Re: License No. 29-00117-07

GAMMA CELL 1000 - RELOCATION

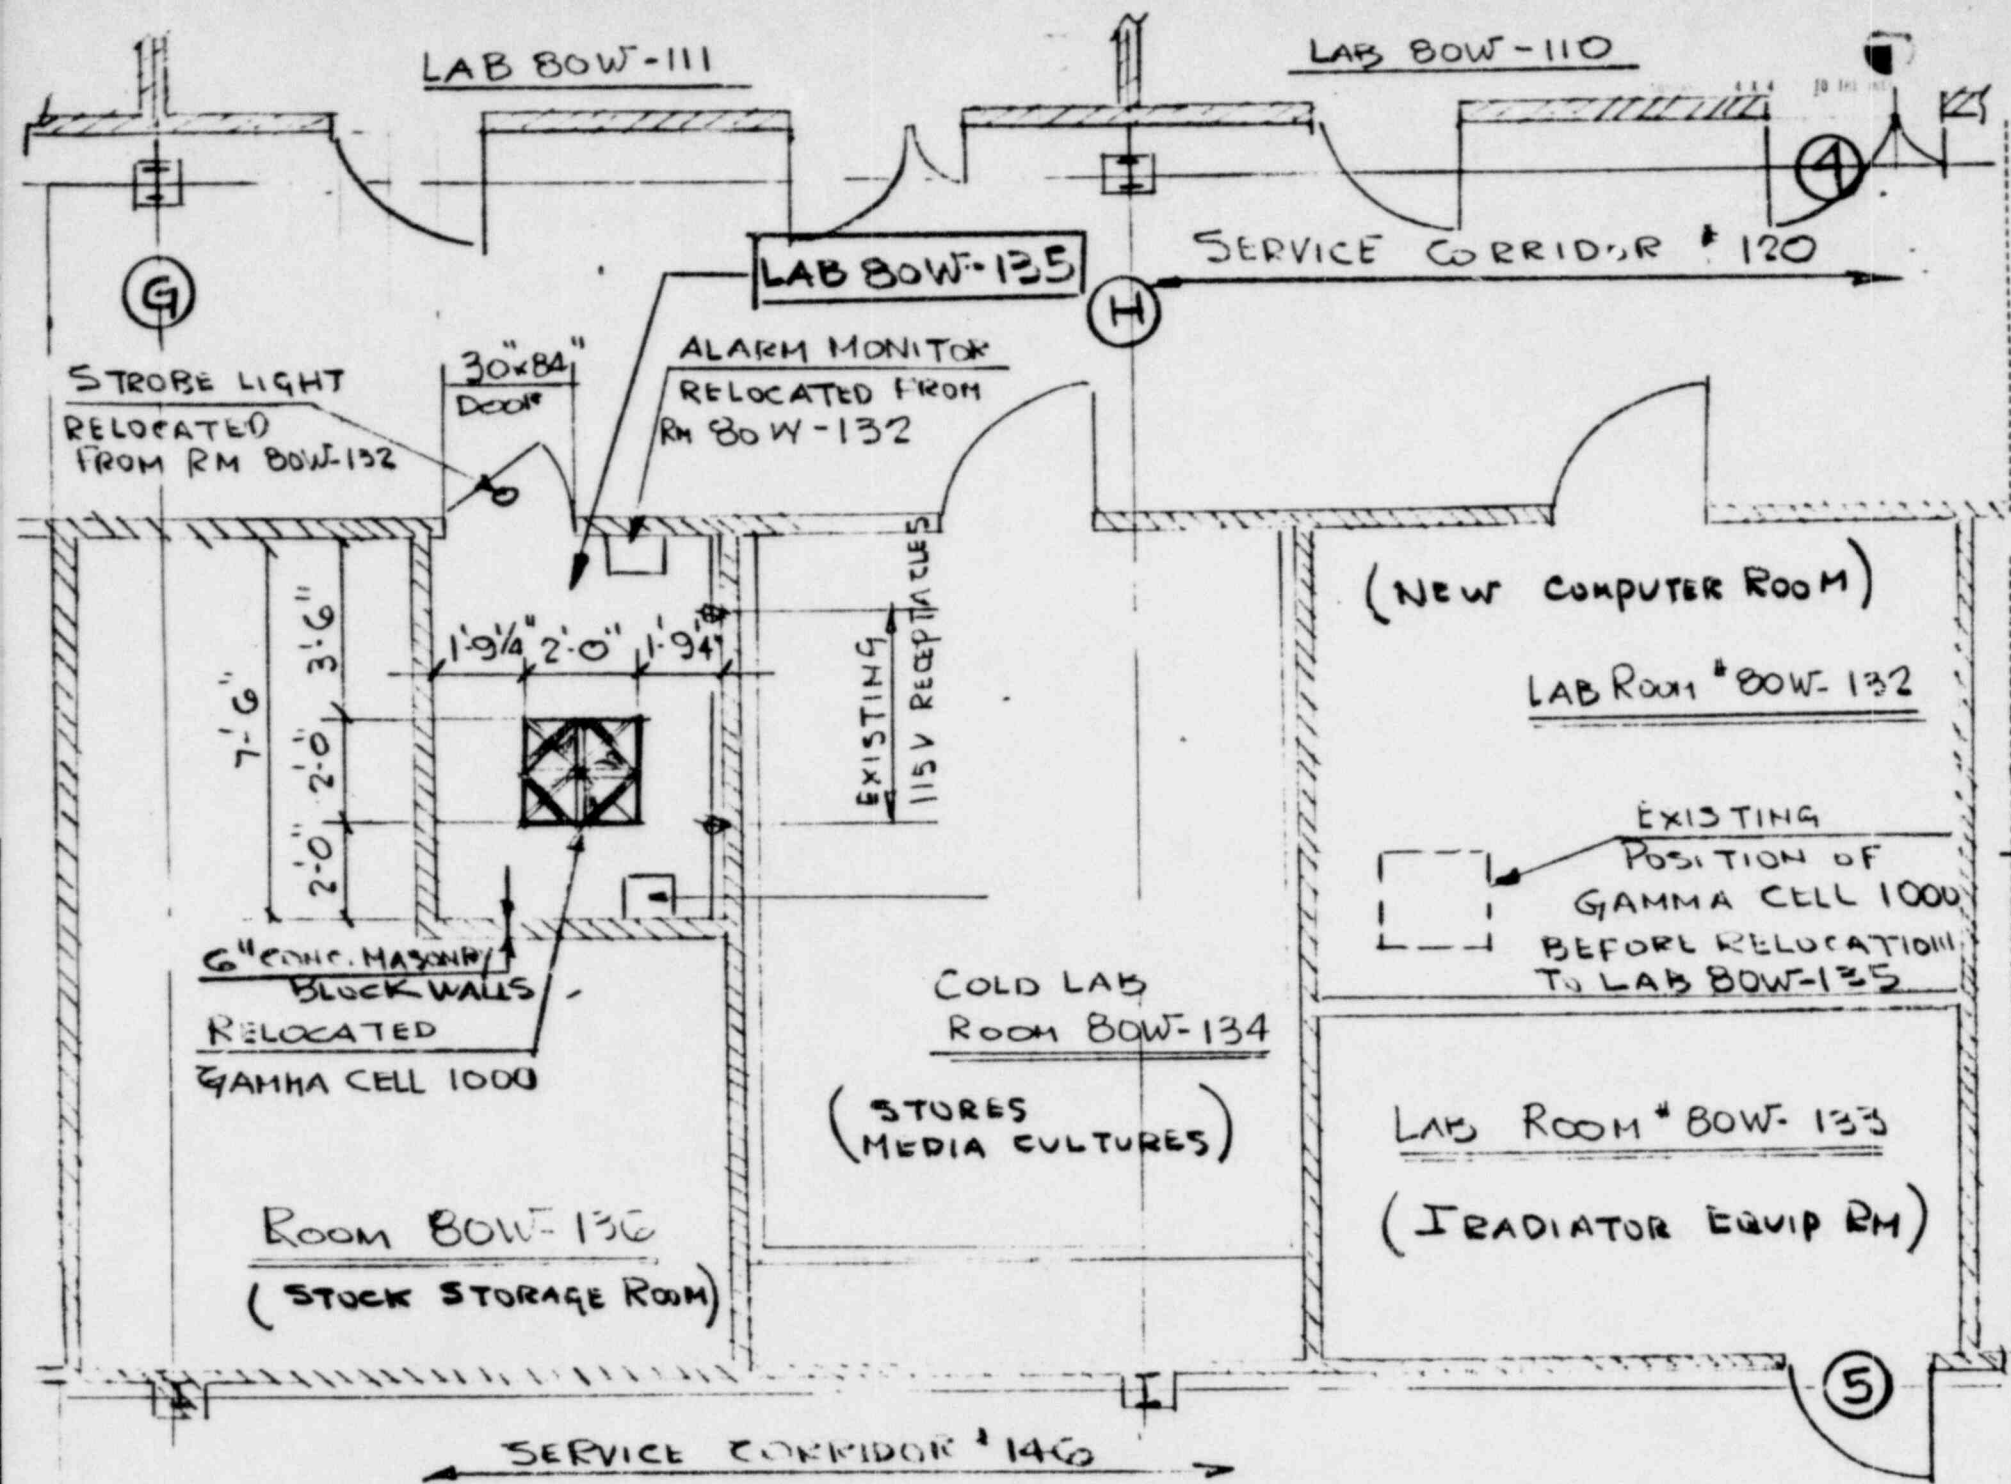
1. It is planned to relocate our Gamma Cell 1000 which contains no more than 3,264 Curies of Cs-137, from its present location in Building 80W, Room No. 132, to Room No. 135 in the same building for efficient utilization of existing space.

2. The attached sketch indicates the planned change.
3. The constant monitoring system and the external visible light warning system will be relocated at the time of the move.
